Cobb County Community Development Agency  
Zoning Division

Case # Z-26  
Public Hearing Dates:  
PC: 05-01-18  
BOC: 05-15-18

Applicant: Austell Cosmetic Dentistry

Proposed use: Senior Independent Living

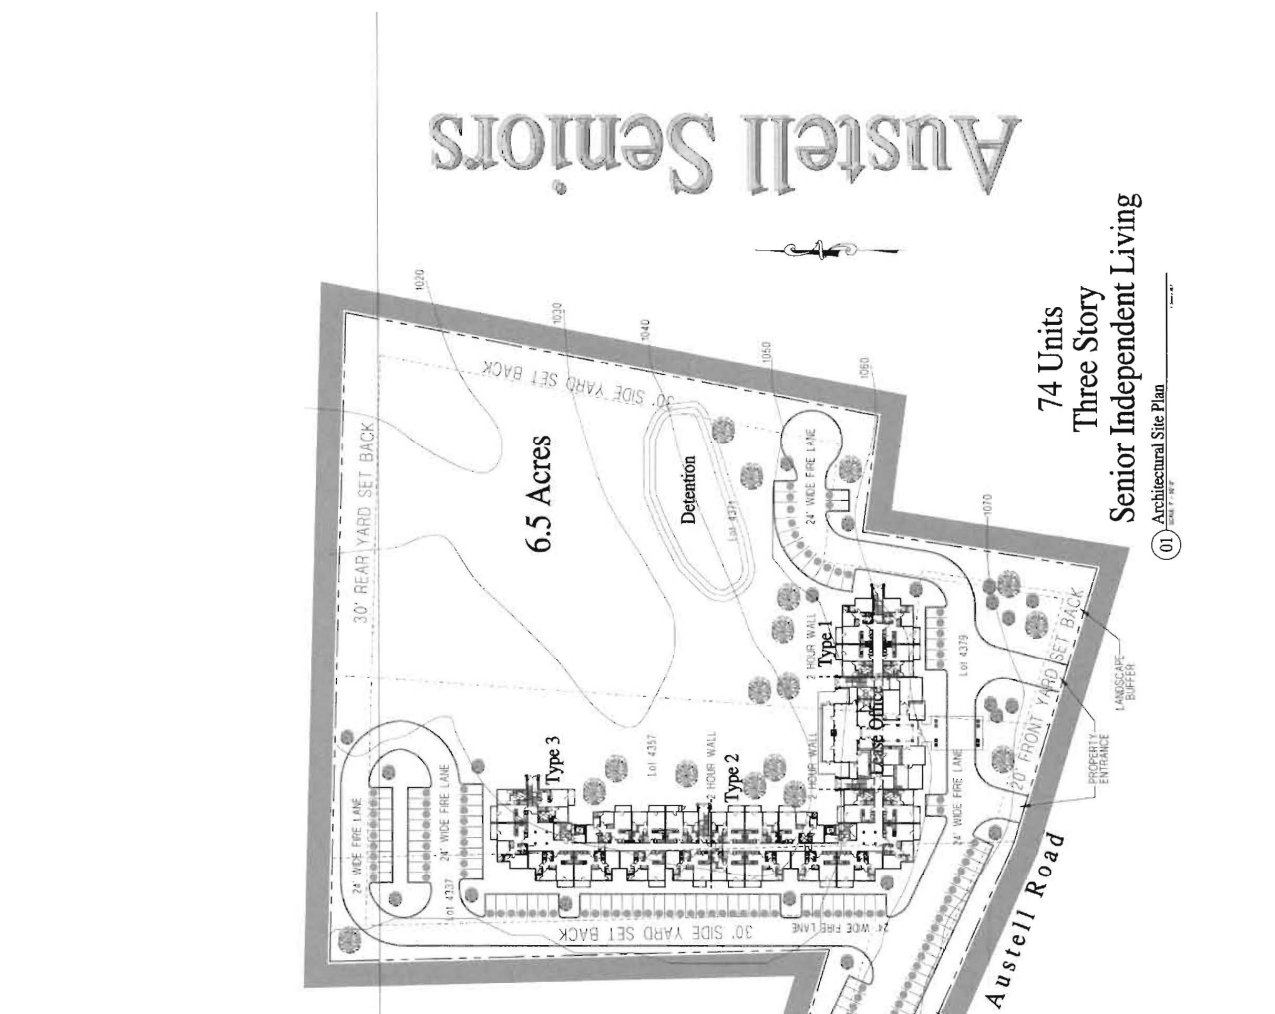
1. Waive the required 50-foot landscape buffer abutting residentially zoned properties;
2. Waive the required 10-foot landscape buffer abutting non-residential properties;
3. Allow more than four units attached side by side;
4. Waive the maximum building height from two stories to three stories; and
5. Waive the maximum density from five units per acre to 11.38 units per acre.

The proposed configuration of the parking areas does not appear to satisfy the Cobb County Tree Ordinance. Additional parking lot peninsulas, as determined during the site plan review process, may be required.

- The proposed detention pond location will require significant grading. It may be possible to relocate the pond to a more natural location centrally in the site depending on field verification of stream buffer limit.
